Re: Request for Approval of Change Order No. 003 for CP2A

Great Water Alliance
Great Lakes Water Supply Program
CP2A - Water Supply Pipeline Section I, II and III Station
Suction Pipelines

CHANGE ORDER

Change Order No.: 003 Rev.: 0.00

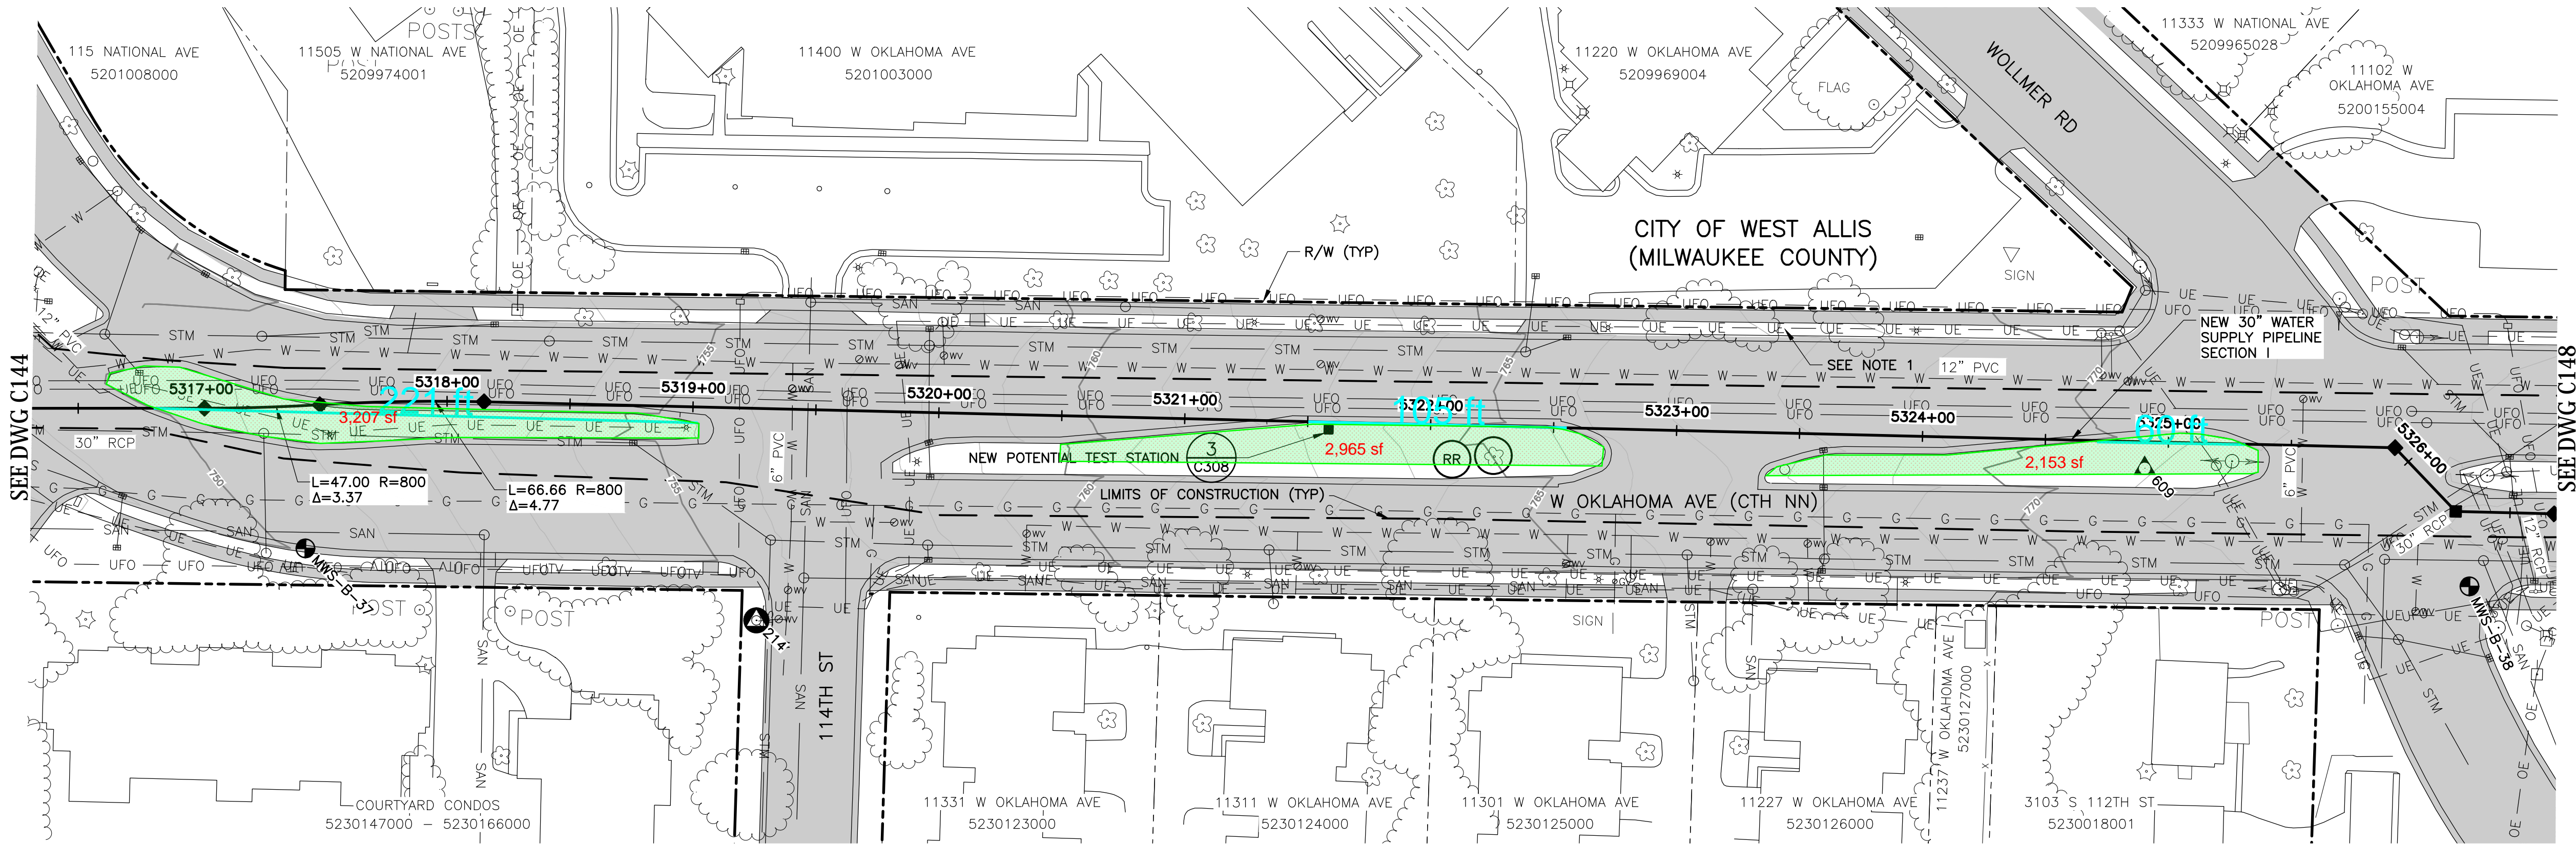
CP2A Sod Restoration Quantities						
Drawing Label	Section I		Section II		Section III	
	Length (LF)	Area (SF)	Length (LF)	Area (SF)	Length (LF)	Area (SF)
[60] 60 C146						
[60] 60 C146	221					
[60] 60 C146	105					
[60] 60 C146	60					
[60] 60 C146		3207				
[60] 60 C146		2965				
[60] 60 C146		2153				
[62] 62 C148	263					
[62] 62 C148	40					
[62] 62 C148	31					
[62] 62 C148	66					
[62] 62 C148		3983				
[62] 62 C148		1268				
[62] 62 C148		2307				
[63] 63 C149	113					
[63] 63 C149		1877				
[63] 63 C149		1233				
[63] 63 C149		260				
[64] 64 C150	18					
[64] 64 C150				1168		
[64] 64 C150				264		
[65] 65 C151				250		
[66] 66 C152				897		
[66] 66 C152				1704		
[66] 66 C152				414		
[68] 68 C154			18			
[68] 68 C154				393		
[68] 68 C154				353		
[68] 68 C154				989		
[68] 68 C154				899		
[70] 70 C156			190			
[70] 70 C156			23			
[70] 70 C156			61			
[70] 70 C156				2663		
[70] 70 C156				683		
[70] 70 C156				1985
